## Access Compliance Report Public Rights-of-Way (Curb Ramps)

Intersection ID: 12928 Main Street: PENMAN\_ST Cross Street: QUINCEY\_ST Location: SW

ADA ID: 9966A054A298 Ramp Type: PerpDiag Initial Pass/Fail: Fail Overall Compliance: No Severity Score: 12.5

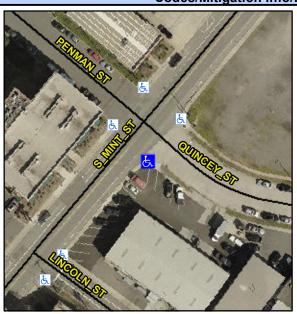
Not Found, R304.5.3

Field Measurements/Component Compliance						
Compliance Description		Data	Compliance		Description	Data
N/A	Ramp Length (in)	72.0	Yes	Ramp	Slope (%)	6.0
Yes	Ramp Width (in)	48.0	No	Ramp	XSlope (%)	5.3
N/A	Flare Type LT	N/A	N/A	Flare	Type RT	N/A
N/A	Flare Slope LT (%)	N/A	N/A	Flare	Slope RT (%)	N/A
N/A	Flare Traversable LT?	N/A	N/A	Flare	Traversable RT?	N/A
N/A	Landing Length (in)	N/A	N/A	DWS	Provided?	N/A
N/A	Landing Width (in)	N/A	N/A	DWS	Contrast?	N/A
N/A	Landing Slope (%)	N/A	N/A	DWS	Length (in)	N/A
N/A	Landing X Slope (%)	N/A	N/A	DWS	Full Width?	N/A
N/A	Landing Curb? (Y/N)	N/A	N/A	DWS	Offset (in)	N/A
N/A	Shared Landing?	N/A				
N/A	Gutter Ponding?	N/A	N/A	Gutte	Slope (%)	N/A
N/A	Gutter Lip Ht (in)	N/A	N/A	Gutte	X Slope (%)	N/A
N/A	Painted X Walk1?	No	N/A	Painte	ed X Walk2?	No
	X Walk 1 Direction	To NE		X Wal	k 2 Direction	To NW
N/A	X Walk 1 Width (in)	N/A	N/A	X Wal	k 2 Width (in)	N/A
	X Walk 1 Slope (%)	0.4		X Wal	k 2 Slope (%)	9.0

Remove & Replace Curb Ramp With Two New Directional Ramps or Equivalent.
